22 March 2021  
Our Ref: 19097.05

## **Application to Amend Planning Permit PA1900743 5MW Solar Energy Facility & Utility Installations McQualters Road, Raywood VIC 3570 (incl. adjacent road reserve)**

Doc No.: 19097.05\_L\_DELWP\_AppToAmendPP\_160321

## Appendix A – Glint and Glare Overview

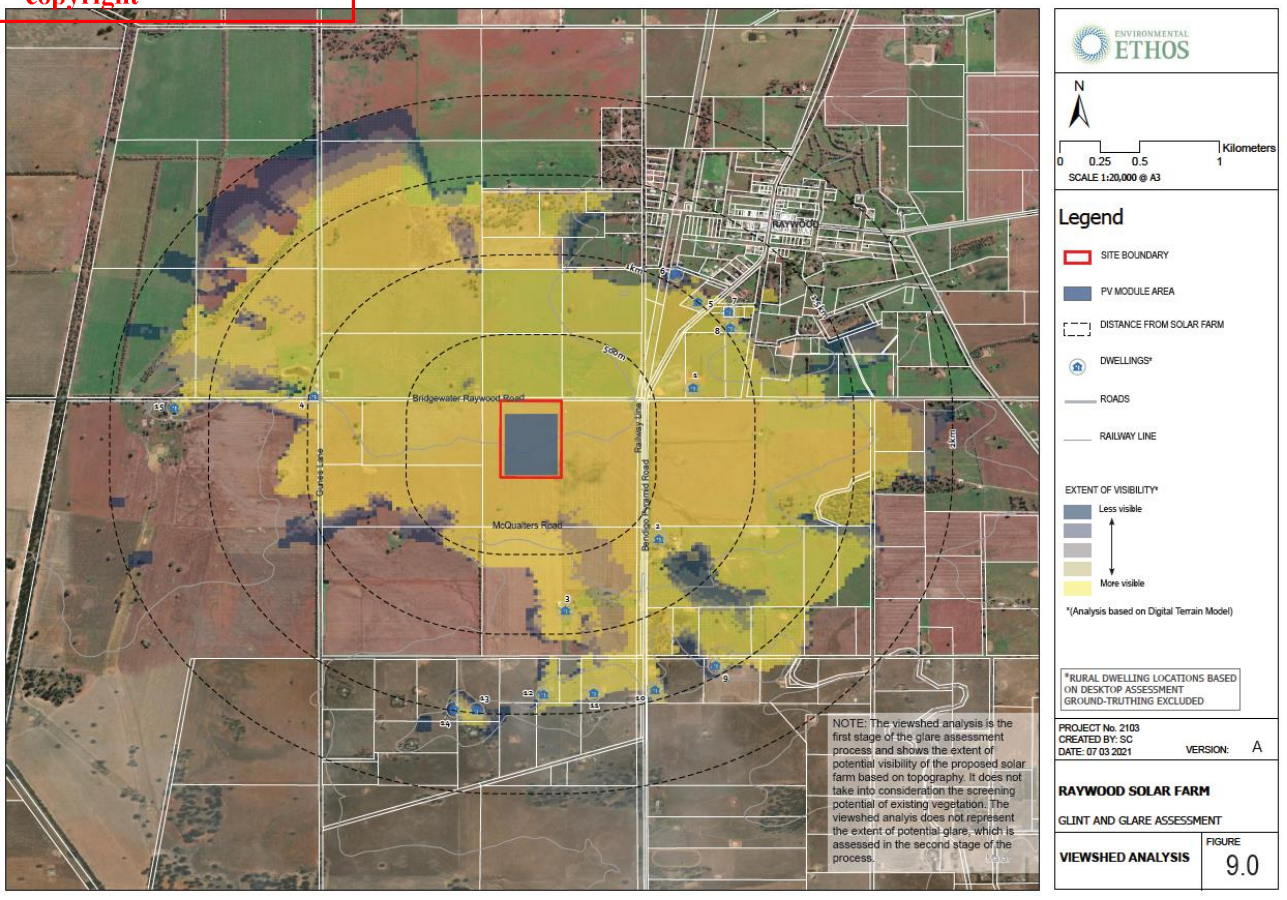
Undertaken by Environmental Ethos, this assessment has considered the potential impact of the amended facility on nearby receptors within a 2km radius of the facility.

Within this radius, there were fifteen (15) dwellings that were identified as having *potential* visibility to the site – illustrated in **Appendix A** of this submission.

There would be no glare on any nearby dwellings, nor any other sensitive receptors as a result of the proposed tracking arrays. This includes any nearby roads, railways and the Raywood airport to the east of the site.
